# Technical product information

<b>Topic</b>	Oil leaking from tell tale hole - CDA actuator fixings or Fuel rail fixings or Vacuum assembly fixings - V8 Kovomo
<b>Market area</b>	Russische Föderation (5RU),Australia E04 Bentley rest Asia and Australia (6E04),China 796 VW Import Comp. Ltd (Vico), Beijing (6796),Germany E02 Bentley rest Europe (6E02),Japan E03 Bentley Japan (6E03),Korea, (South) E08 Bentley South Korea (6E08),United Arab Emirates E06 Bentley Middle East and Africa (6E06),United Kingdom E01 Bentley UK (6E01),United States E05 Bentley USA and rest America (6E05)
<b>Brand</b>	Bentley
<b>Transaction No.</b>	2064679/2
<b>Level</b>	EH
<b>Status</b>	Released for publishing
<b>Release date</b>	04-Nov-2022

Figure 1

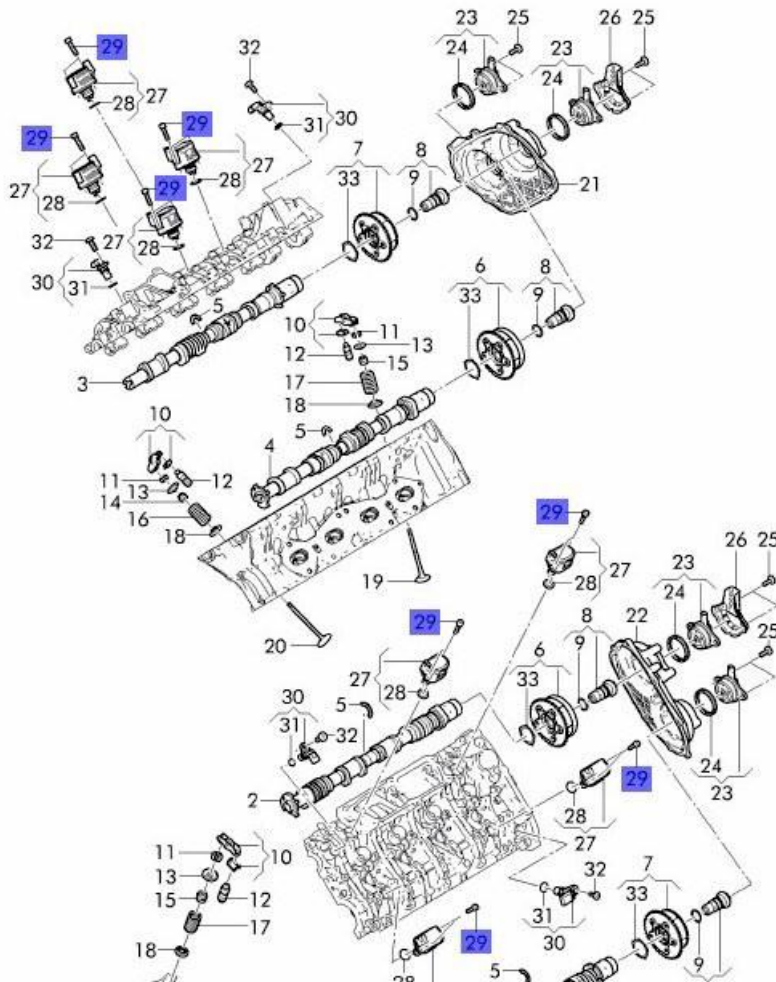
- CDA activation/ deactivation solenoid fixings - Figure 1 (Item 29 - Quantity of 16 in total)

- In the event that x1 (or more) of the CDA solenoid fixing/s are leaking – All 16 CDA solenoid fixings MUST BE REPLACED as a complete set - Refer to Rep.Gr 15 - Ensuring the procedure is followed to enable access to all CDA solenoid fixings

Figure 2

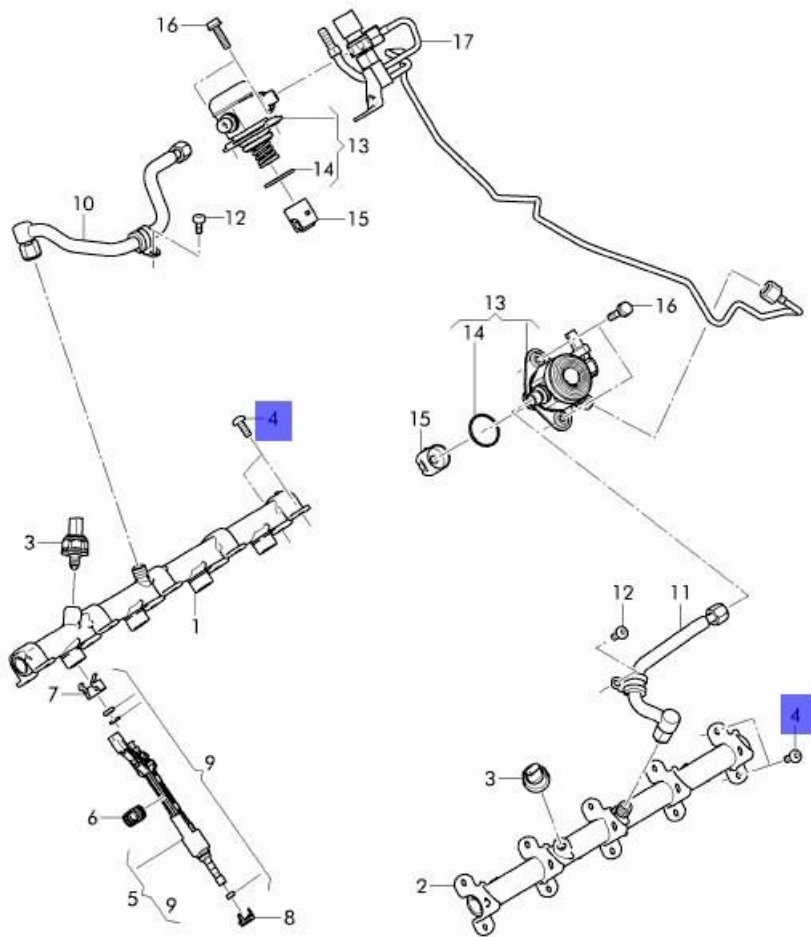
- Fuel rail fixings - Figure 2 (Item 4 - Quantity of 20 in total)

- Refer to Rep.Gr24- Fuel rails to remove and refit- Ensure the procedure is followed to enable access to the fuel rail fixings on both Banks 1 and 2 - Replace all 20 fixings

Figure 3

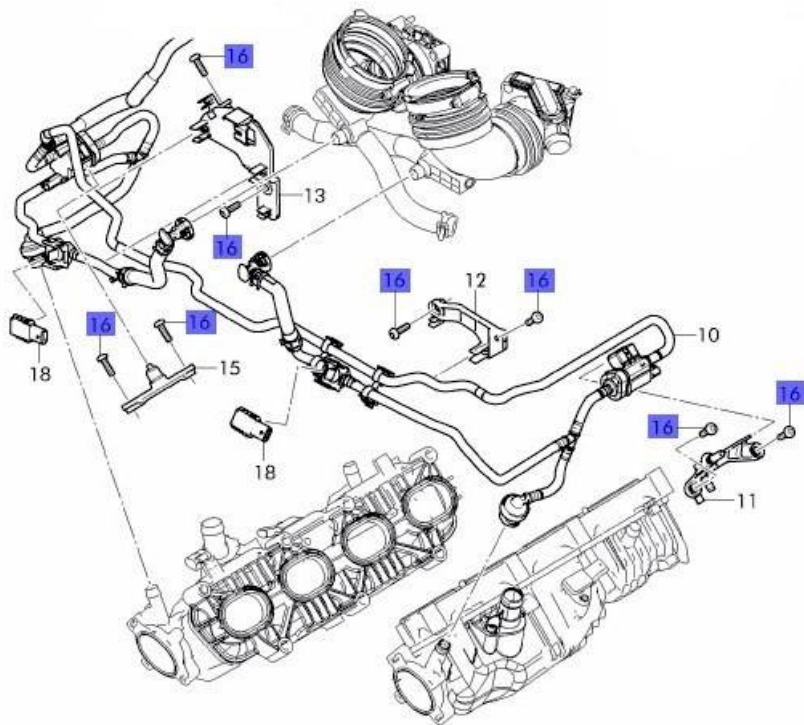
- Fixings for the vacuum system assembly - Figure 3 (Item 16 – Quantity of 8 in total)

1) To gain access to the fixings, the Operative should refer to extracts from the following procedures to replace the fixings:

- Rep.Gr20 - Evaporative Emission Purge Valve and Rep.Gr28 - Ignition coil replacement

Figure 4

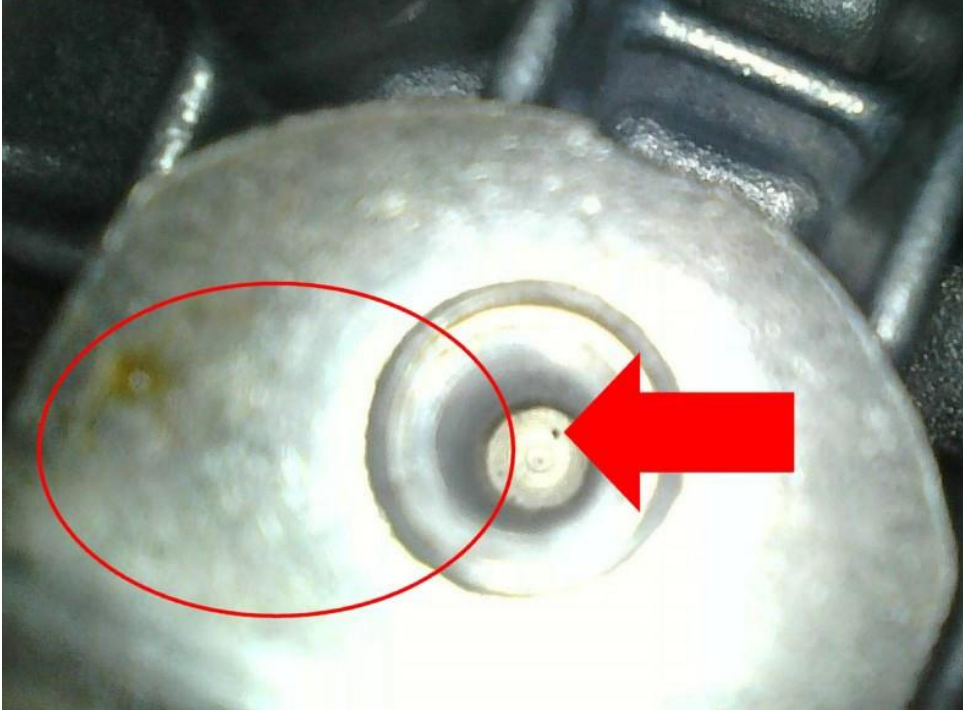
Figure 4 shows oil leaked which had leaked from the tell tale hole at the top of the fixing (Arrow)

- Upgraded fixings prevent oil leaks from the tell hole
